# UNITED STATES PATENT AND TRADEMARK OFFICE

APPLICATION NO.	FILING DATE	FIRST NAMED INVENTOR	ATTORNEY DOCKET NO.	CONFIRMATION NO.
10/530,225	12/05/2005	Jarmo Smahl	13162-016US1 2021973US	8066
26161 7590 01/28/2008 FISH & RICHARDSON PC P.O. BOX 1022 MINNEAPOLIS, MN 55440-1022			EXAMINER KEE, FANNIE C	
			ART UNIT 3679	PAPER NUMBER
			MAIL DATE 01/28/2008	DELIVERY MODE PAPER

<b>Office Action Summary</b>	Application No.	Applicant(s)	
	10/530,225	SMAHL, JARMO	
	Examiner	Art Unit	
	FANNIE C. KEE	3679

## **DETAILED ACTION**

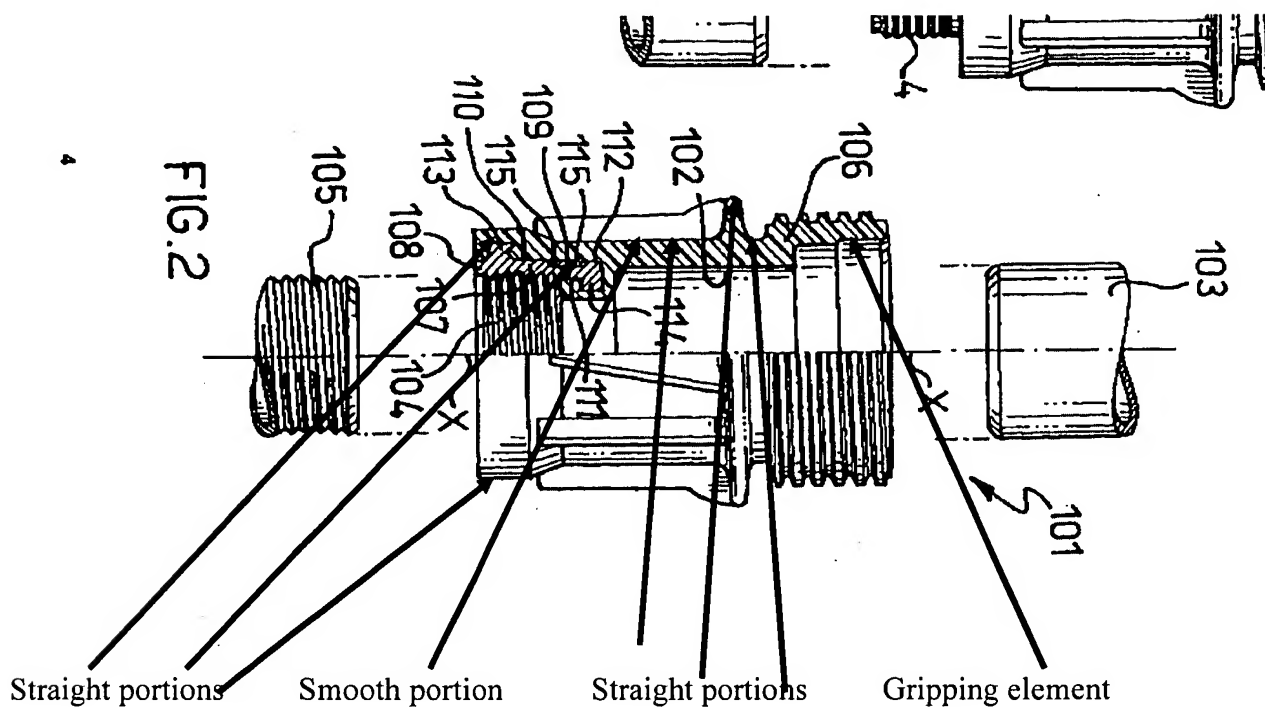
With regard to claim 1, and as best understood by Examiner, Mazzacano et al disclose a connecting piece (101), intended for connecting at least two elements, whereby a first element (105) is connected to a first end of the connecting piece and a second element (103) is connected to a second end of the connecting piece, the connecting piece being comprising a body (106)

mainly of plastic, at least one end of the connecting piece a metal insert (108) provided with a thread (104), whereby at least one element is connectable to the connecting piece with threaded connection and at least one gripping element on the outer surface of the connecting piece for rotating the connecting piece or keeping it still upon making the threaded connection, that the gripping element comprises at least two straight portions such that two straight portions on opposite sides of the connecting piece are parallel, the straight portions forming gripping surfaces for a tool, and a portion which is arranged smooth between adjacent straight portions, whereby the gripping element is formed such that the tool round the gripping element slips before the thread and/or the basic structure of the connecting piece gets damaged (see Figure 2 below).

With regard to claim 2, and as best understood by Examiner, Mazzacano et al disclose the gripping element comprising six straight portions (see Figure 2 above).

With regard to claim 3, and as best understood by Examiner, Mazzacano et al disclose the gripping element being formed of two or more ribs in the direction of the periphery of the connecting piece (see Figure 2 above).

With regard to claim 4, and as best understood by Examiner, Mazzacano et al disclose the outer surface of the metal insert being provided with ribs (113, 114) in the direction of the periphery, the ribs of the metal insert and the ribs on the outer surface of the connecting piece being arranged at the same point (see Figure 2).

With regard to claim 5, and as best understood by Examiner, Mazzacano et al disclose the portion which is arranged smooth being a rounded portion (see Figure 2 above).

With regard to claim 6, and as best understood by Examiner, Mazzacano et al disclose a connecting piece (101), intended for connecting at least two elements, whereby a first element (105) is connected to a first end of the connecting piece and a second element (103) is connected to a second end of the connecting piece, the connecting piece comprising a body (106), at least one end of the connecting piece a thread (104), whereby at least one element is connectable to the connecting piece with threaded connection and at least one gripping element on the outer surface of the connecting piece for rotating the connecting piece or keeping it still upon making the threaded connection, the gripping element comprising at least two straight portions such that two straight portions on opposite sides of the connecting piece are parallel, the straight portions forming gripping surfaces for a tool and a portion which is arranged smooth between adjacent straight portions, whereby the gripping element is formed such that the tool round the gripping element slips before the thread of the connecting piece gets damaged (see Figure 2 above).

With regard to claim 7, and as best understood by Examiner, Mazzacano et al disclose the gripping element comprising six straight portions (see Figure 2 above).

With regard to claim 8, and as best understood by Examiner, Mazzacano et al disclose the gripping element being formed of two or more ribs in the direction of the periphery of the connecting piece (see Figure 2 above).

With regard to claim 9, and as best understood by Examiner, Mazzacano et al disclose the portion which is arranged smooth being a rounded portion (see Figure 2 above).
